Access Compliance Report

Public Rights-of-Way

(Curb Ramps)

Intersection ID: 9140	Main Street: FREEDOM_DR	Cross Street: THRIFTWOOD_DR	Location: NW
ADA ID: 63323AD7BD47	Ramp Type: Para	Initial Pass/Fail: Fail	Overall Compliance: No
		Severity Score: 12.5

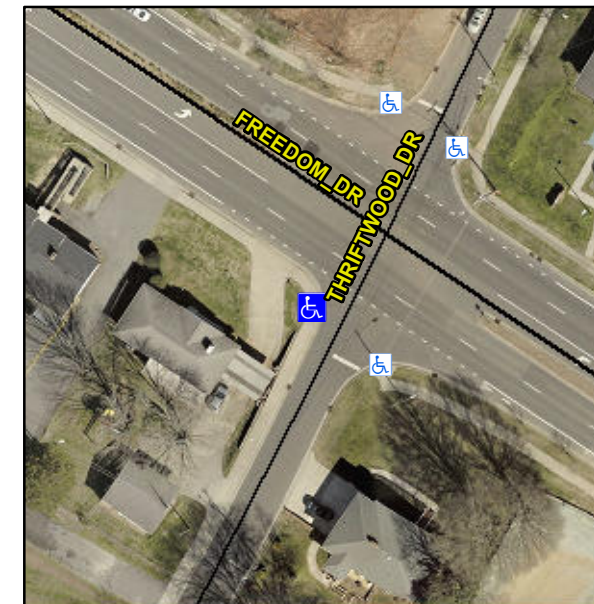
LT RP < 5%

R304.3.2

Compliance	Description	Data	Compliance	Description	Data
N/A	Ramp Length LT (in)	60.0	N/A	Ramp Length RT (in)	50.0
Yes	Ramp Width LT (in)	68.2	Yes	Ramp Width RT (in)	68.0
Yes	Ramp Slope LT (%)	4.3	No	Ramp Slope RT (%)	9.7
Yes	Ramp XSlope LT (%)	1.3	Yes	Ramp XSlope RT (%)	0.3
N/A	Landing Length (in)	N/A	N/A	DWS Provided?	N/A
N/A	Landing Width (in)	N/A	N/A	DWS Contrast?	N/A
N/A	Landing Slope (%)	N/A	N/A	DWS Length (in)	N/A
N/A	Landing X Slope (%)	N/A	N/A	DWS Full Width?	N/A
N/A	Landing Curb? (Y/N)	N/A	N/A	DWS Offset (in)	N/A
N/A	Shared Landing?	N/A			
N/A	Gutter Ponding?	N/A	N/A	Gutter Slope (%)	N/A
N/A	Gutter Lip Ht (in)	N/A	N/A	Gutter X Slope (%)	N/A
N/A	Painted X Walk1?	No	N/A	Painted X Walk2?	N/A
	X Walk 1 Direction	To SE		X Walk 2 Direction	N/A
N/A	X Walk 1 Width (in)	N/A	N/A	X Walk 2 Width (in)	N/A
	X Walk 1 Slope (%)	6.1		X Walk 2 Slope (%)	N/A
	X Walk 1 X Slope (%)	3.1		X Walk 2 X Slope (%)	N/A
N/A	Ramp inside XWalk1?	N/A	N/A	Ramp inside XWalk2?	N/A

Remove & Replace Entire Ramp.
